Your Ref
M/122/18/HH
Our Ref
PLAN-025204
Date
22/11/2018

Proposal: Single storey rear extension & alterations.
Site: 56 Southdean Close, Middleton-On-Sea, PO22 7TH.
M/122/18/HH

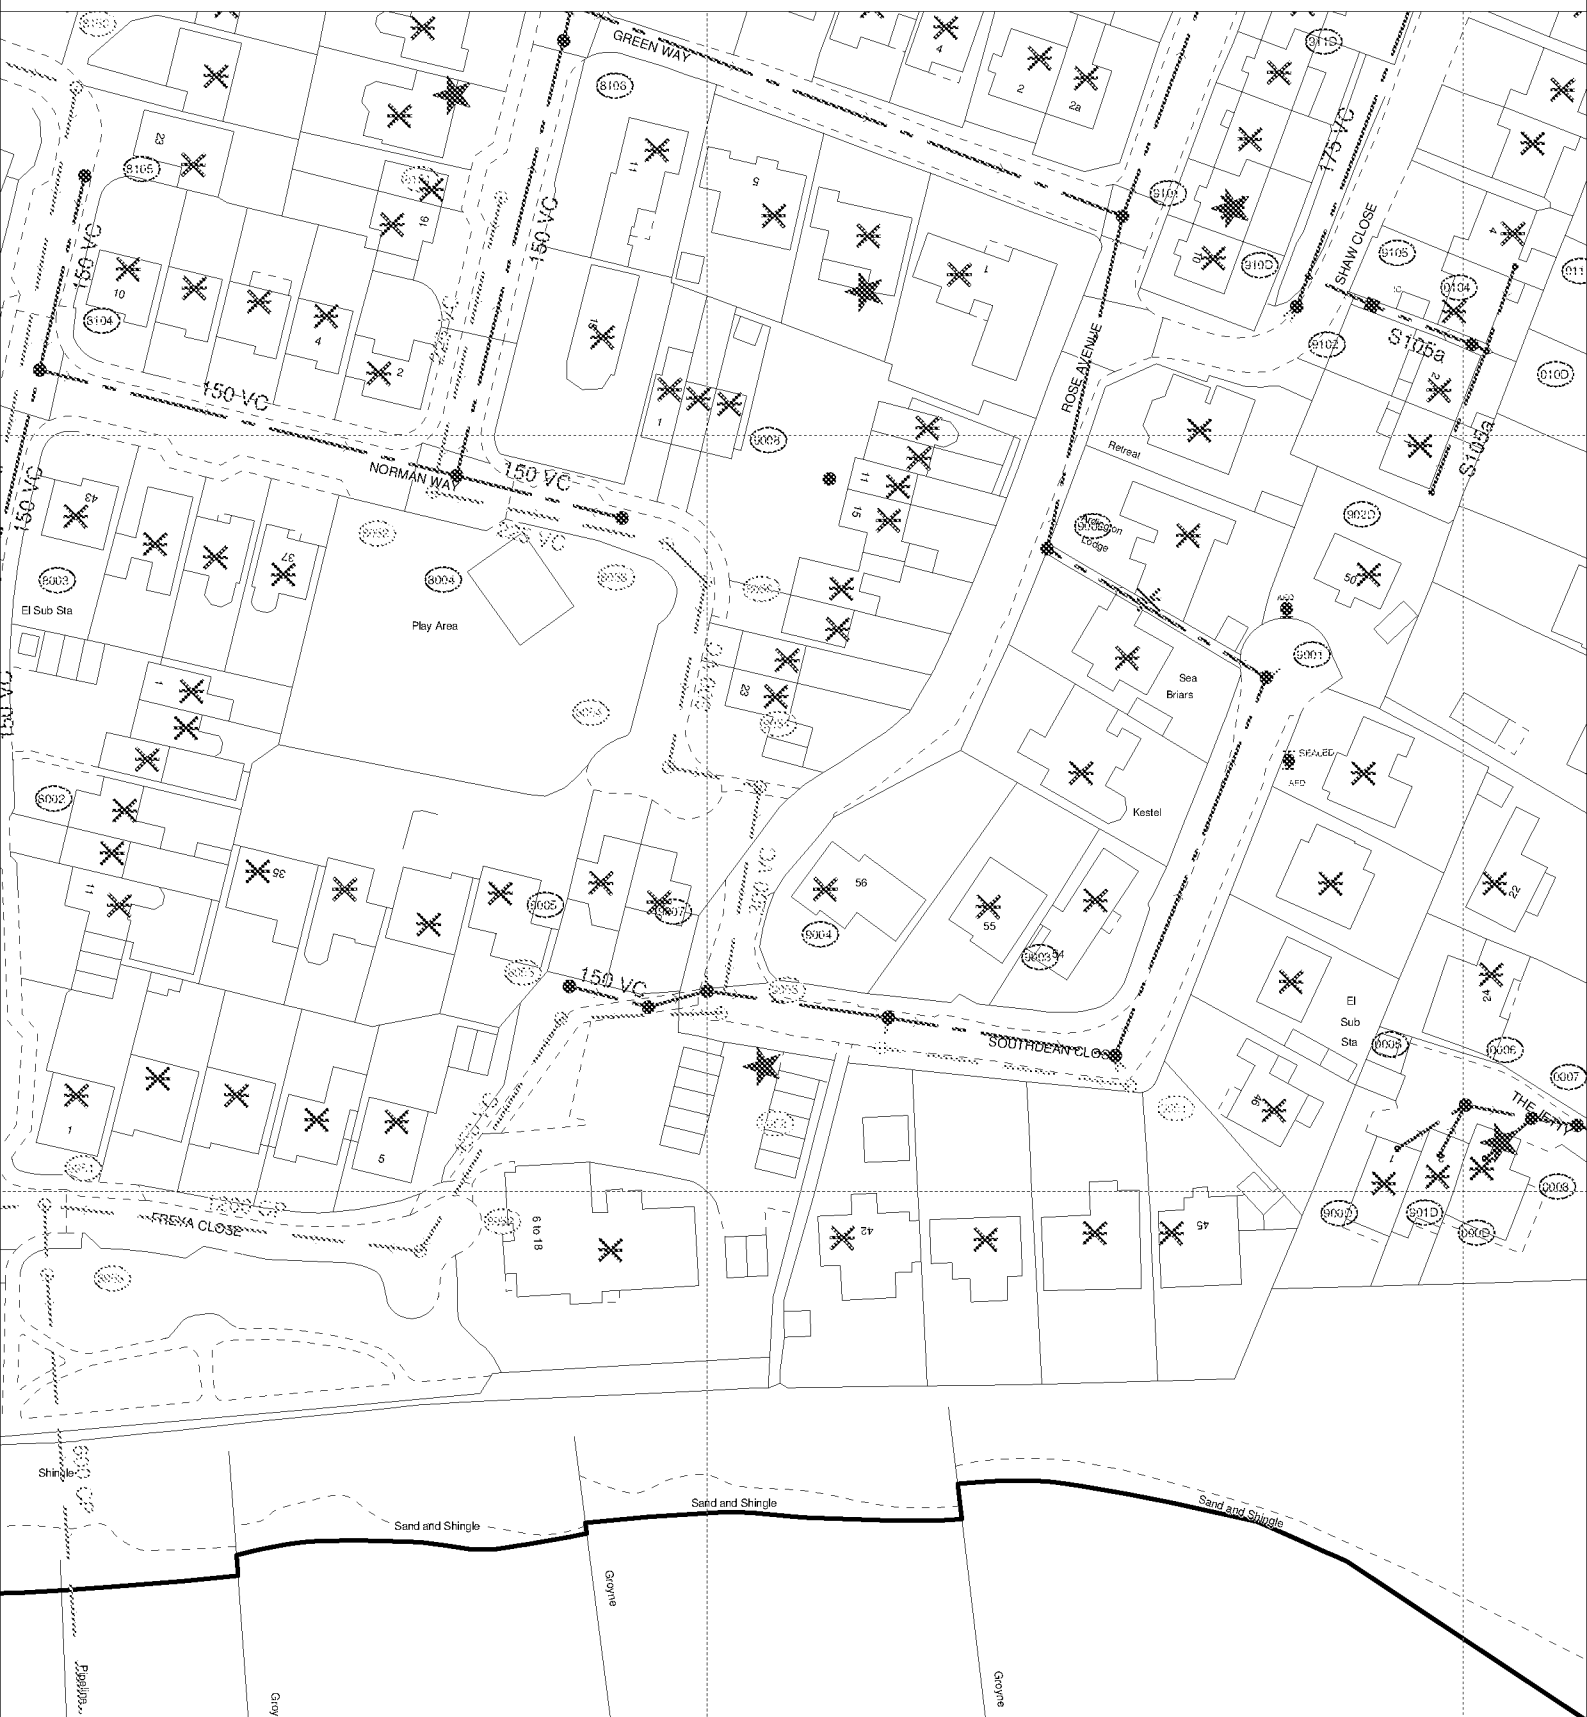
Due to surface water inundation issues in the Lidsey Catchment "The applicant is advised to adopt, where appropriate, the measures in the table "Practical measures to reduce the potential impacts of development".

Developer should look to protect the public sewerage system from inundation and infiltration, which contribute to flooding in unfavourable conditions.
